ADDENDUM ONE

Project: **Sullivan County Immunization**

November 11, 2022

This Addendum is part of the Contract Documents for the above referenced project and modifies the original drawings and/or specifications, dated **10/27/22**, as noted below. The bidder shall acknowledge receipt of this Addendum in the place provided in the Bid Form. The published bid date and time shall remain the same.

SITE PLAN

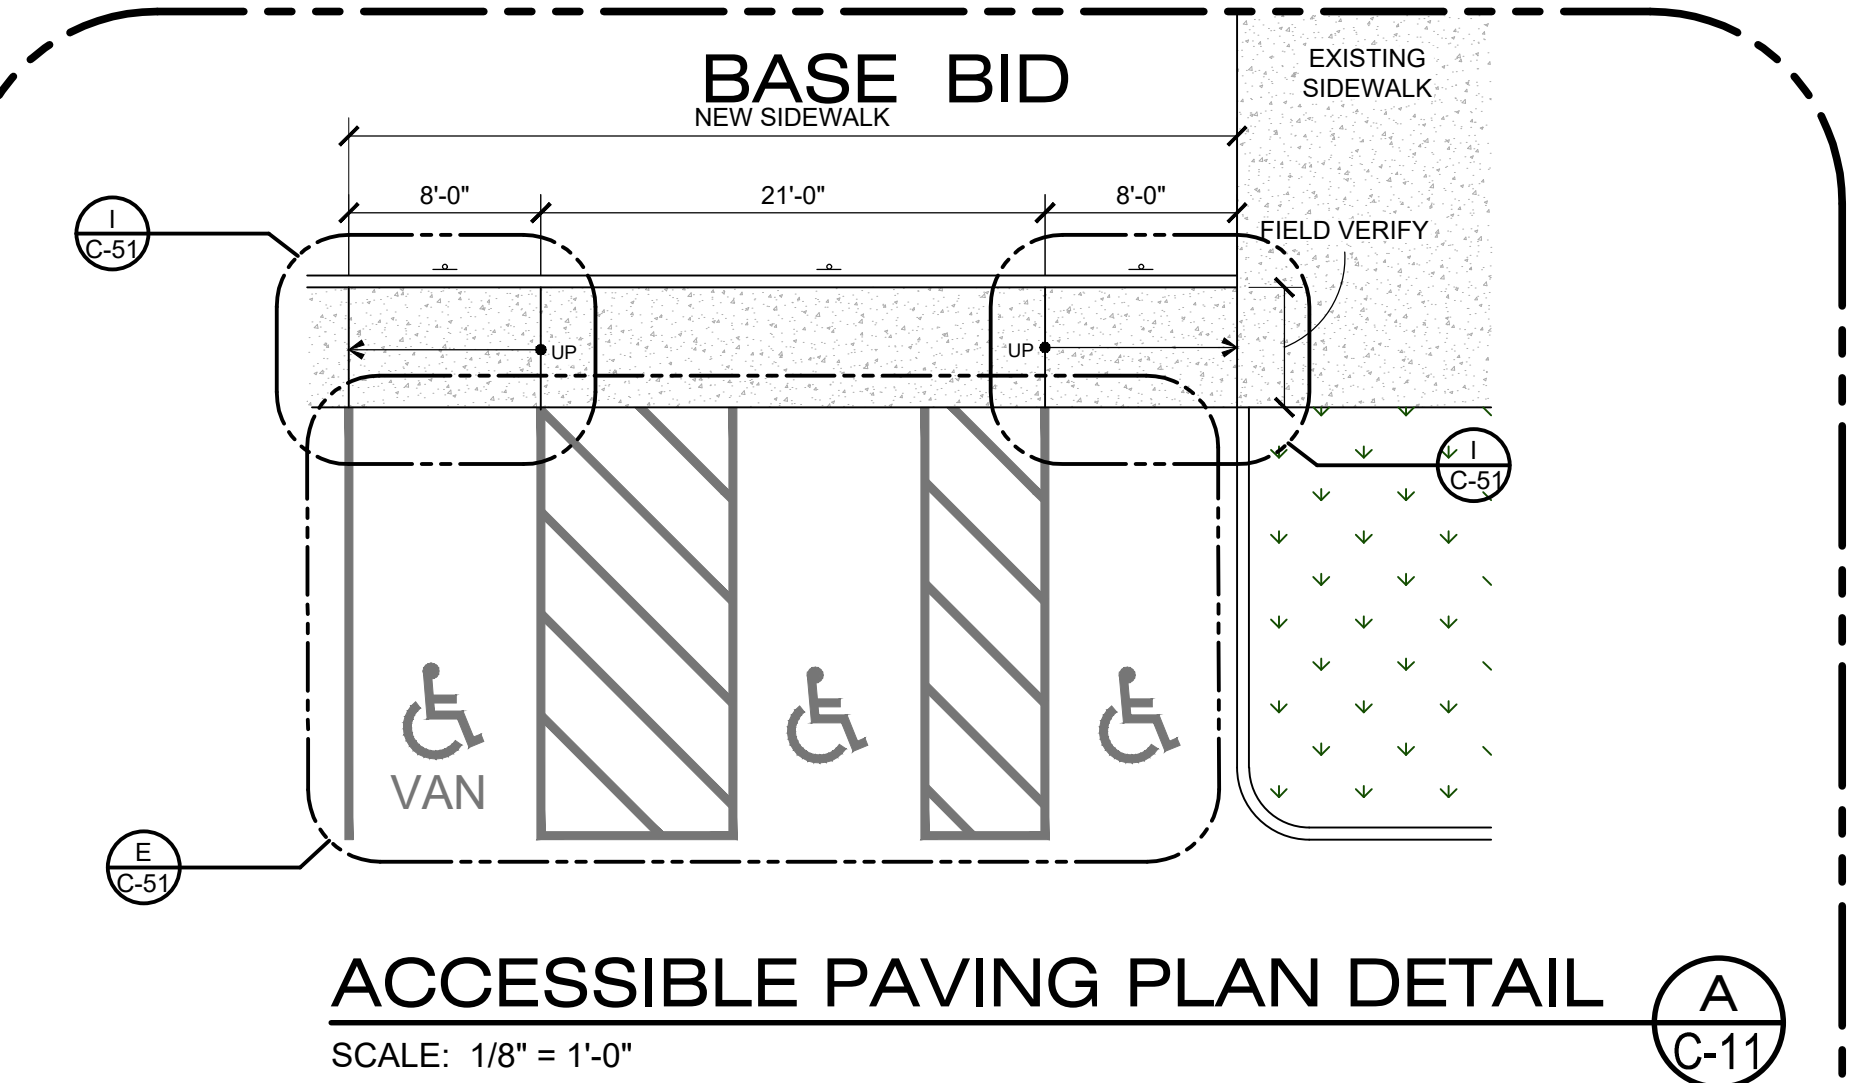
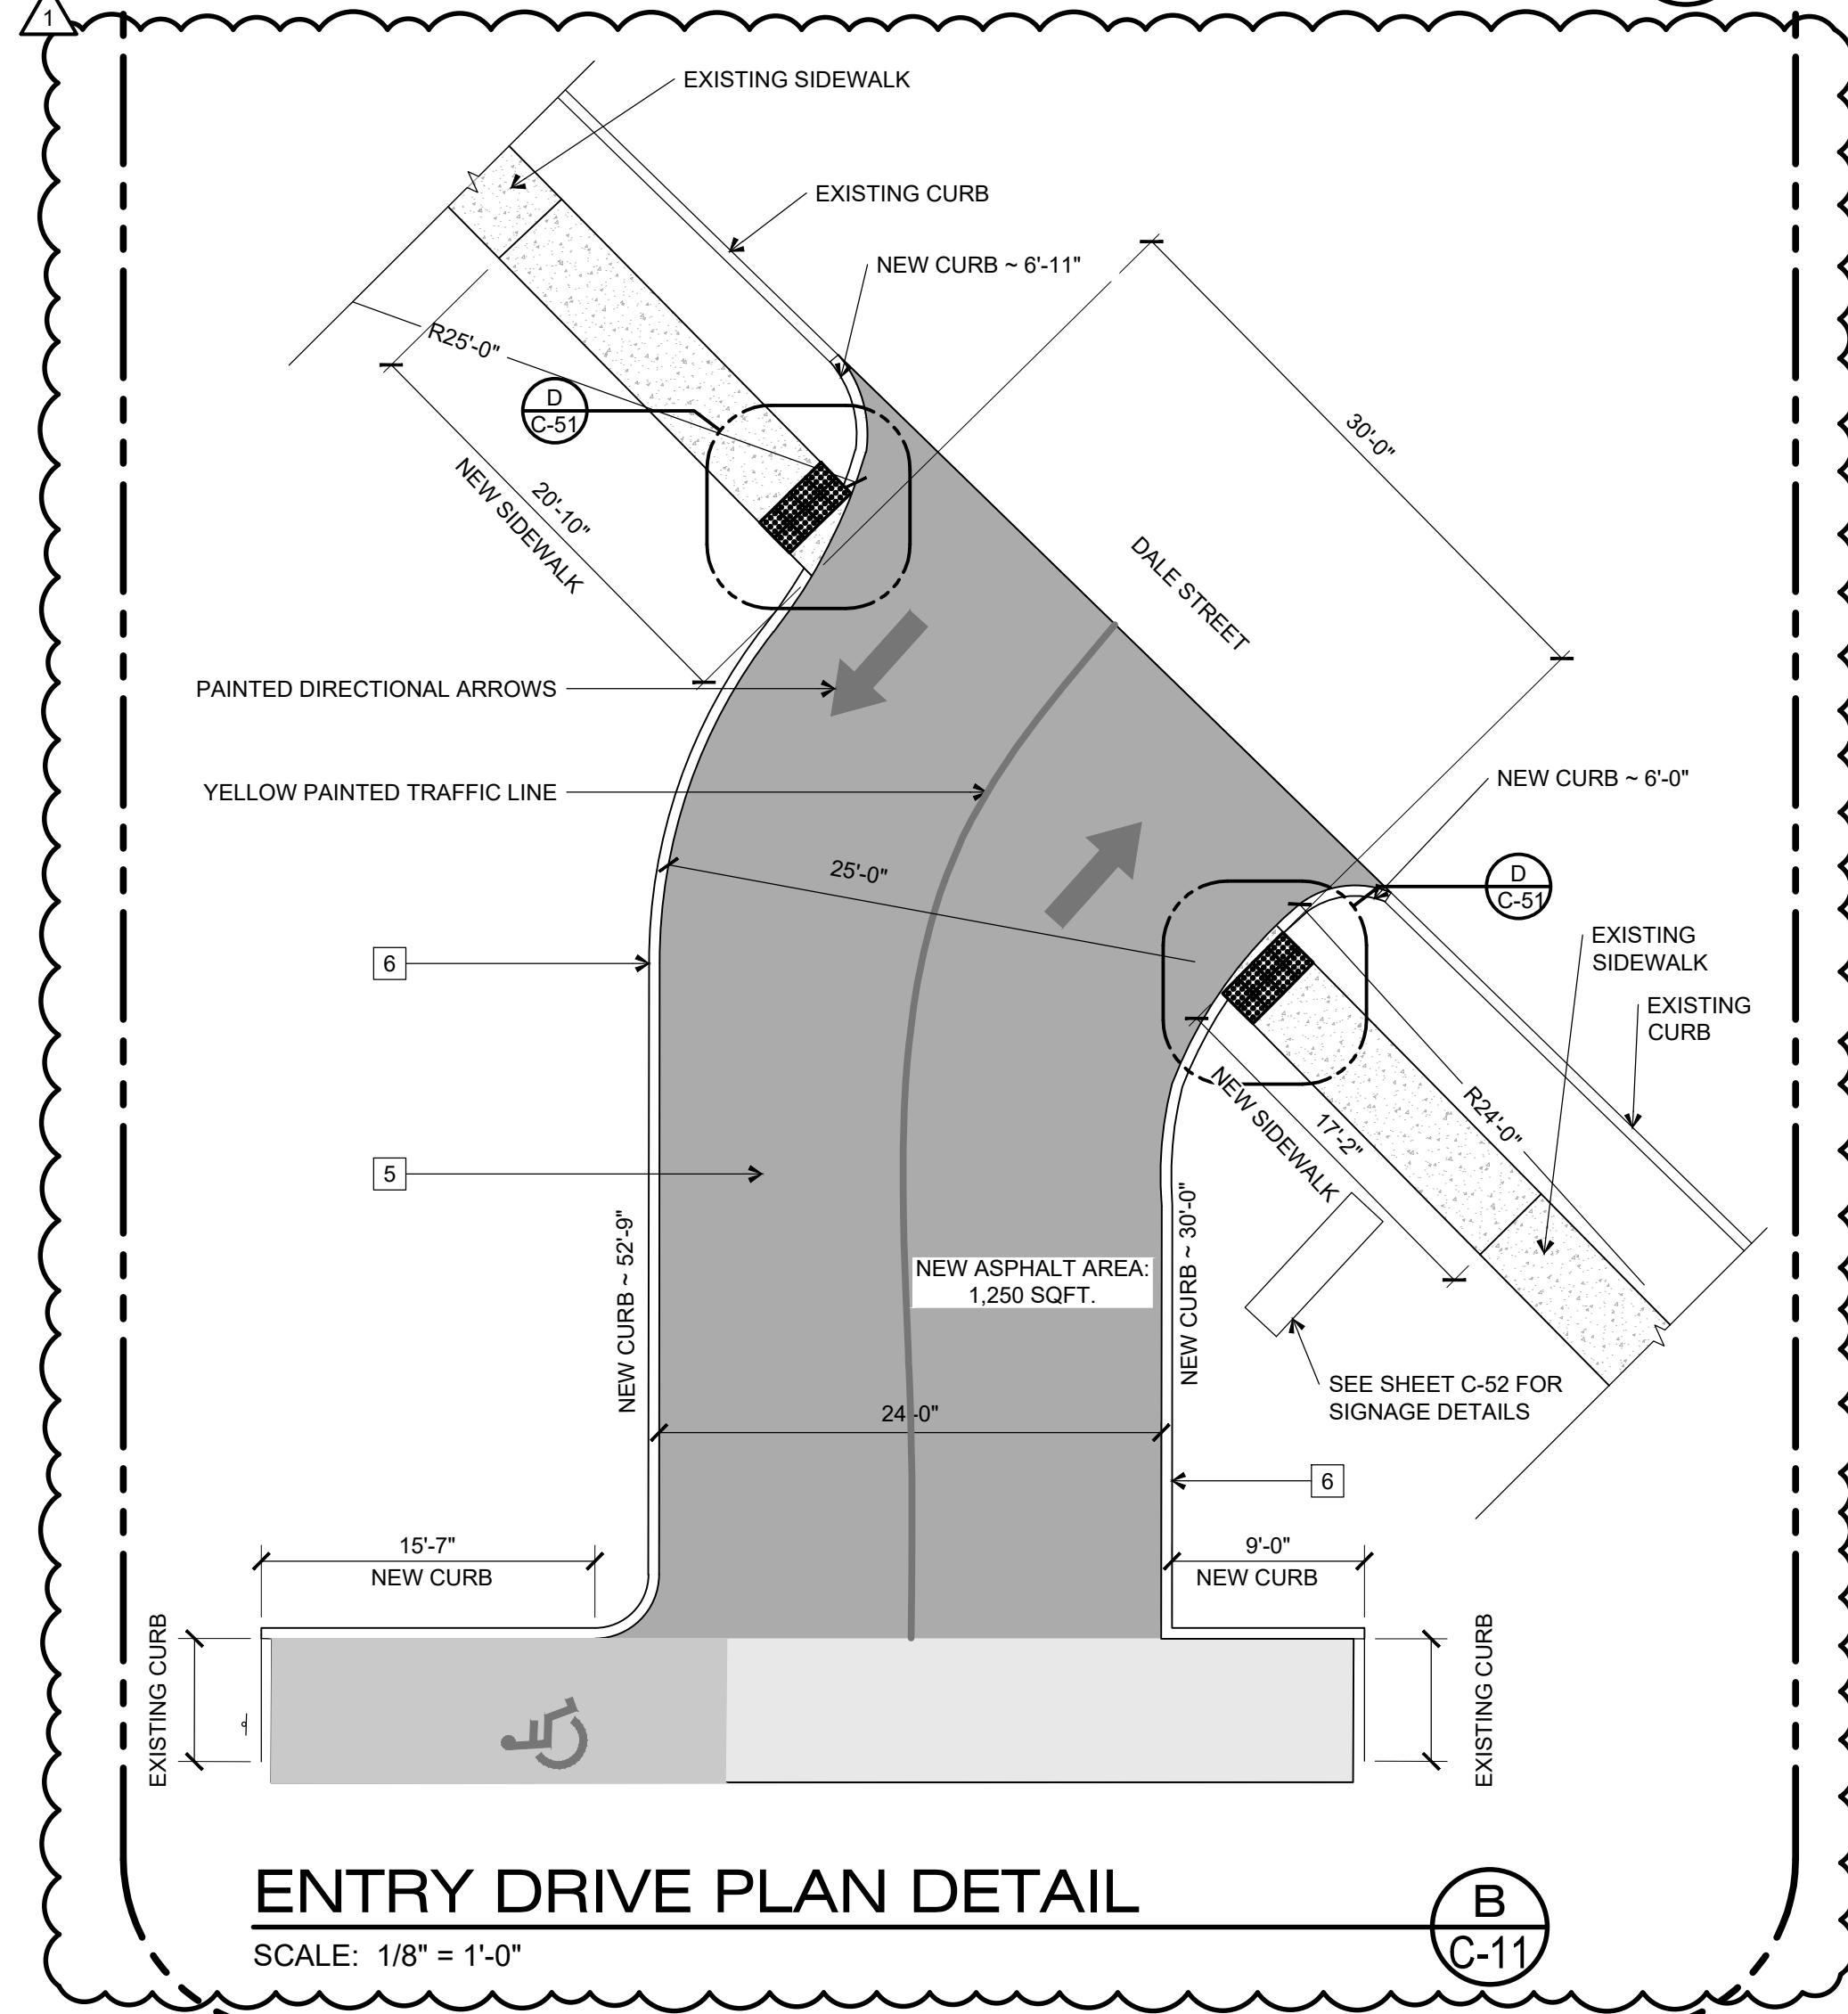
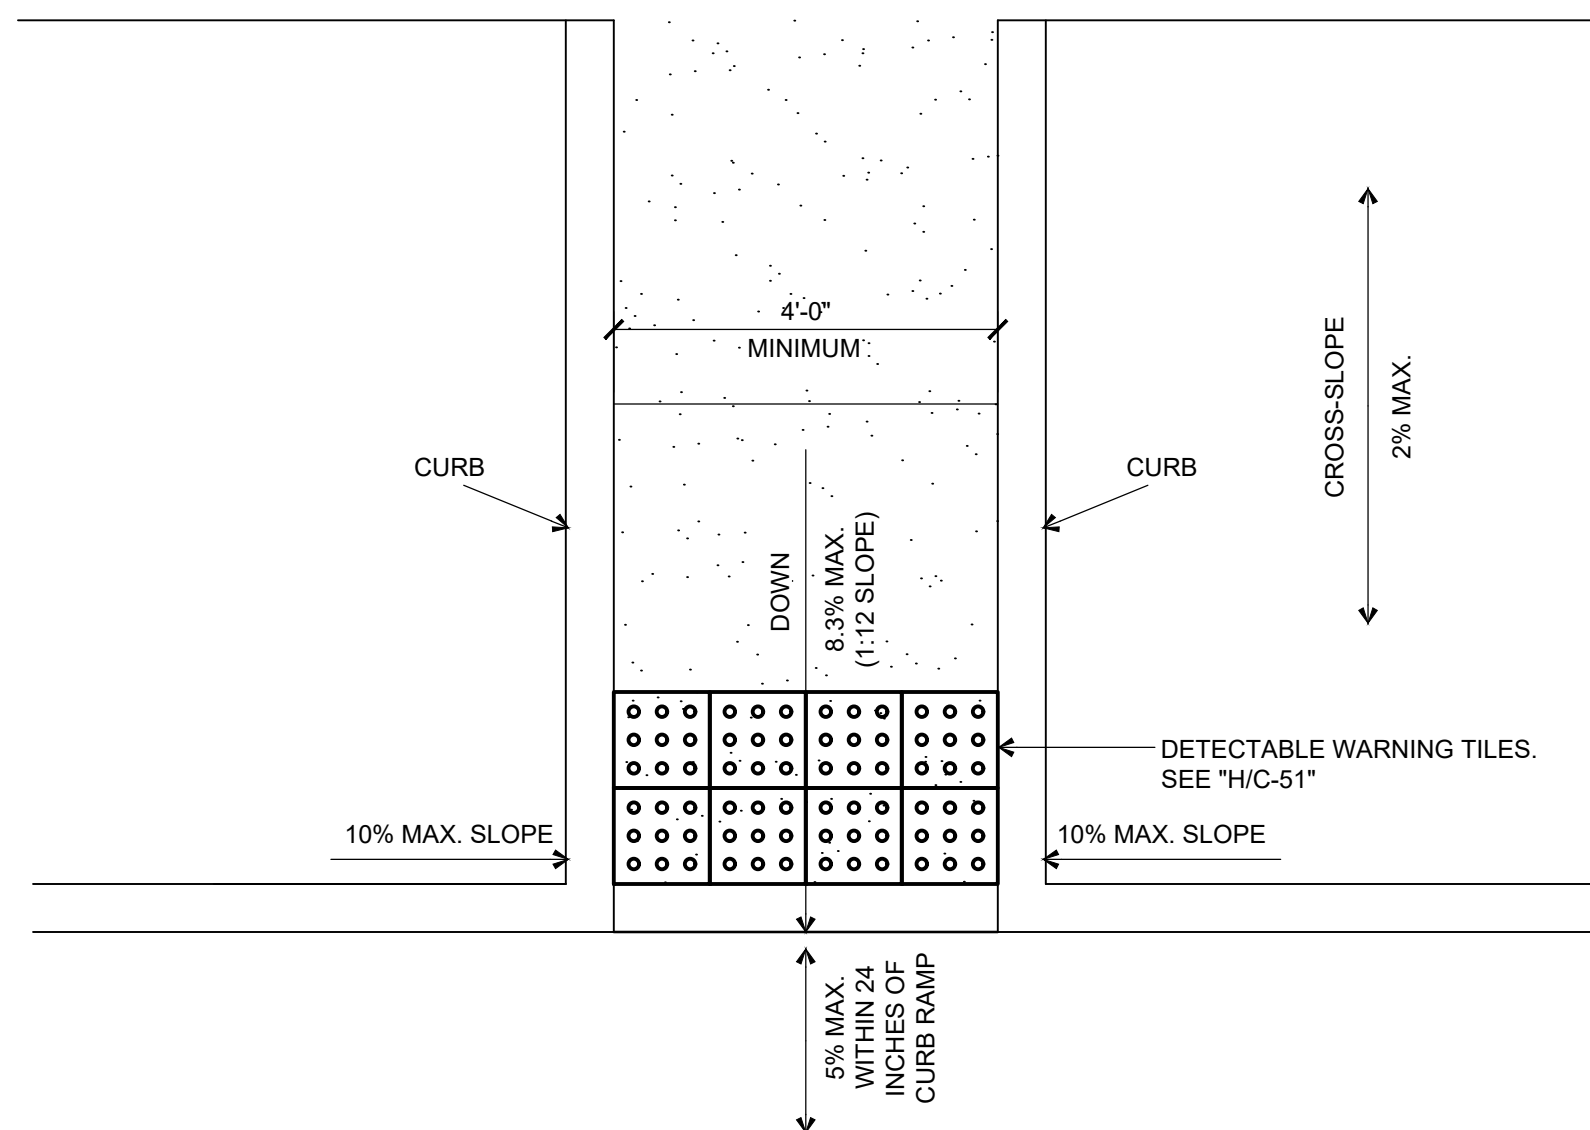
1. **Sheet G-00 Cover Sheet** – updated.
2. **Sheet G-11 Life Safety Plan** – update to code data.
3. **Sheet C-11 Site Layout** – clarification on scope of work.
